COUNTY OF SAN MATEO PLANNING AND BUILDING

SUBJECT: Coastside Design Review

Farallone Avenue, Montara

APN 036-017-050; County File No. PLN 2015-00011

DRAKE 19900Z-GU24

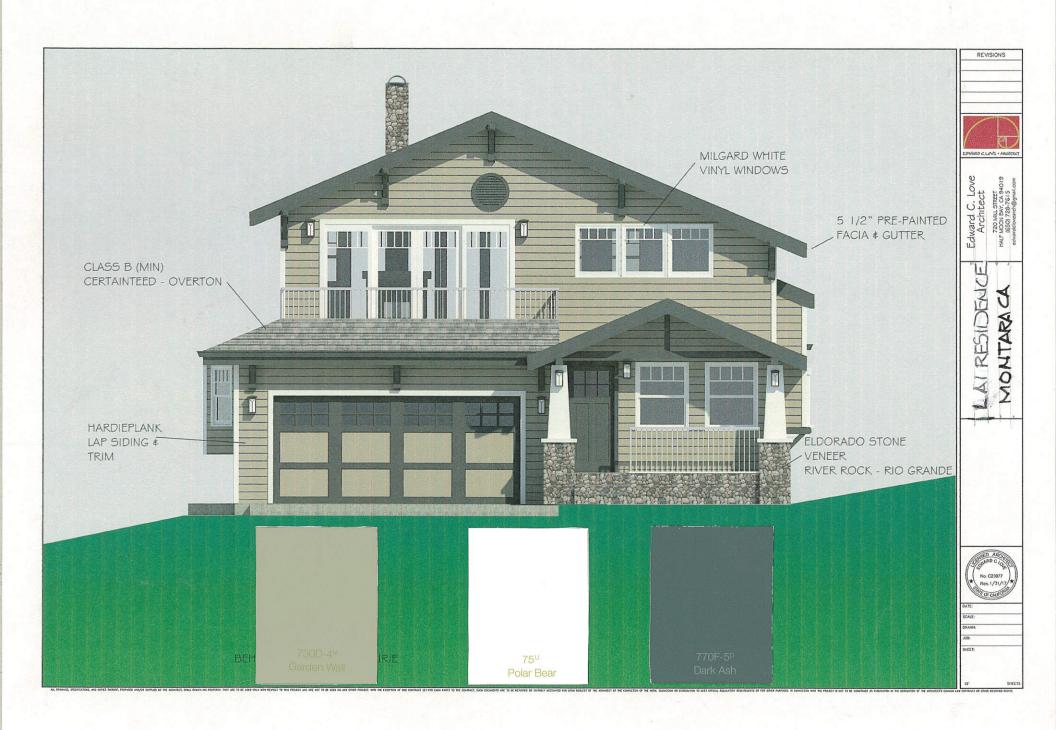
ADJACENT TO BE DESIGNED LATER IN DIFFERENT STYLE.
- 8. Extend the projecting bays to the roof line and change the roof form over bay to gable end. DONE
- 9. Use downward directed exterior lighting fixtures and provide manufacturer's specifications.

ELEVATION AST - SOUTH

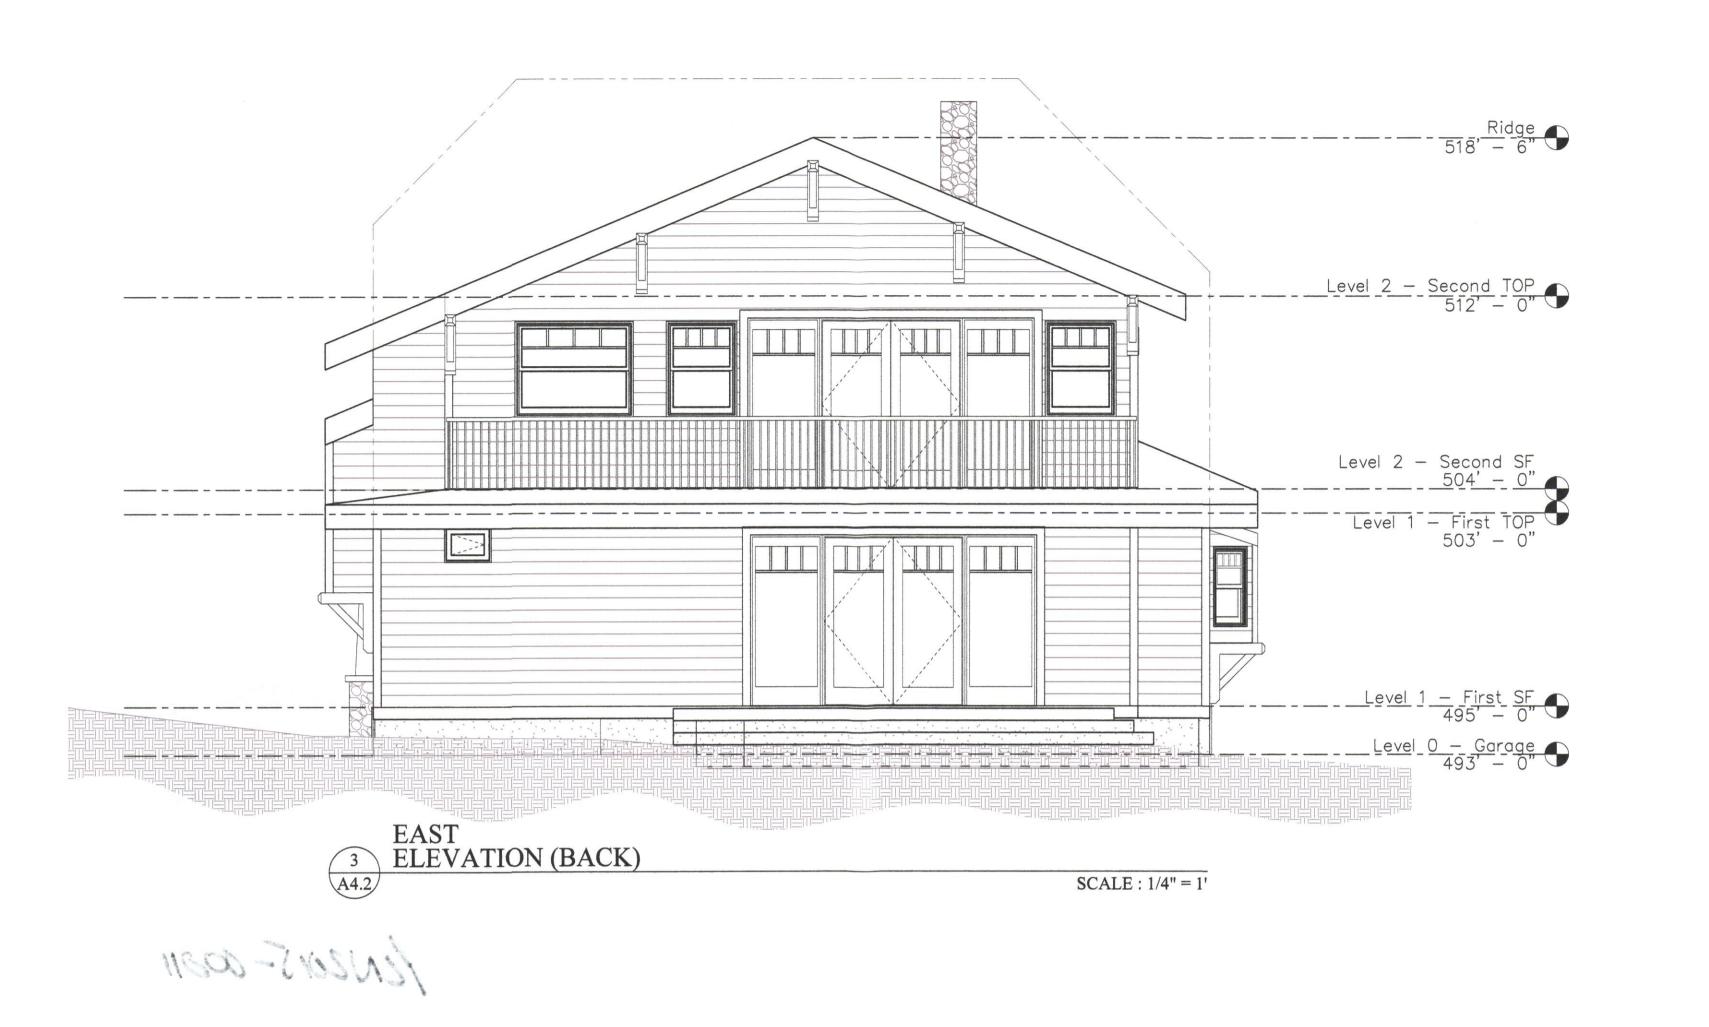
- 1. Reduce the height of the building to more closely match the existing neighborhood context (i.e., reference the height of 335 5th Street). DONE
- 2. Increase the recessed areas of the second floor to a minimum 24 inches. DONE
- 3. Set the building lower into the topography to achieve better integration with the surrounding neighborhood.
- 4. Add articulation to the second story at the sides and rear, such as using staggered walls (gaps) and shingles for the exterior material. DONE
- 5. Consider acquiring the services of a landscape professional to revise the landscape plan such that proposed landscaping presents a natural non-linear appearance.
- 6. Use pervious pavers for all proposed paved areas. DONE

MAX. HEIGHT © 28' ABOVE NATURAL GRADE AT RIDGE
